# **Proposed Technical Specifications**

**3.2.B and 4.2.B**

**Primary Containment Isolation**

REACTOR CORE ISOLATION COOLING SYSTEM ISOLATION INSTRUMENTATION

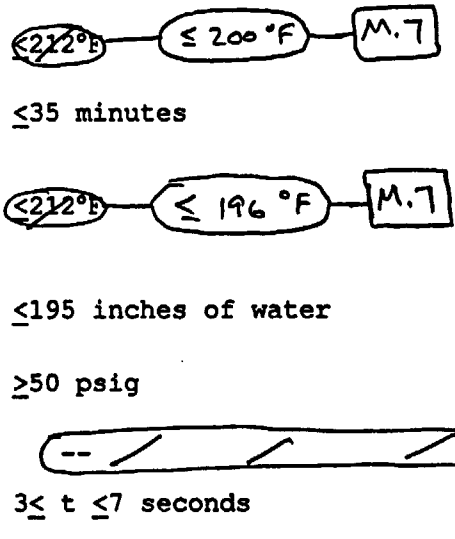
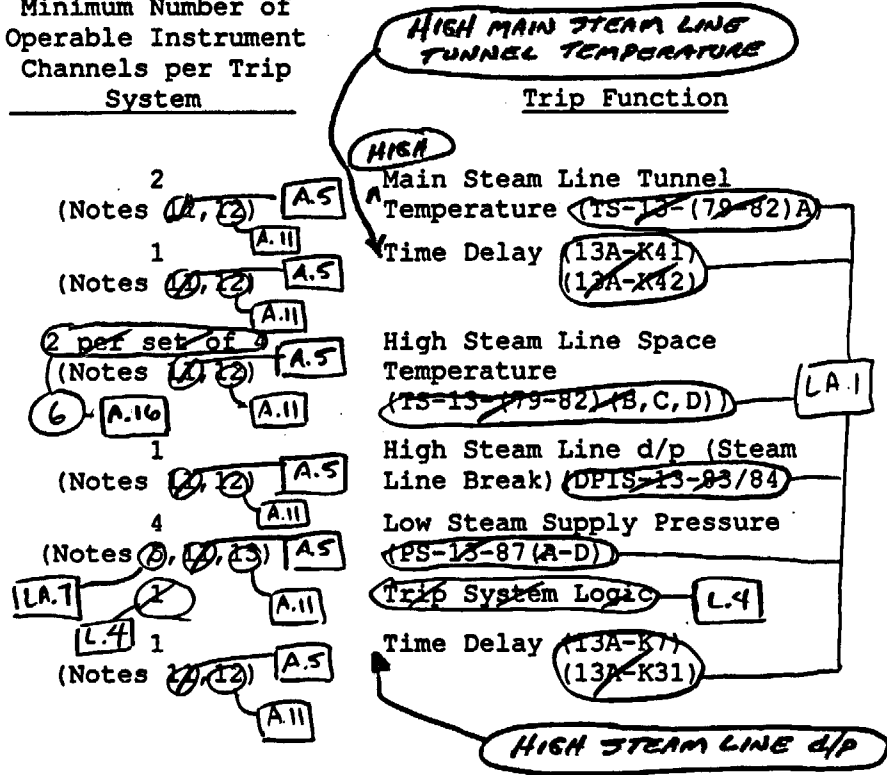
ADD ACTION NOTE 2.2
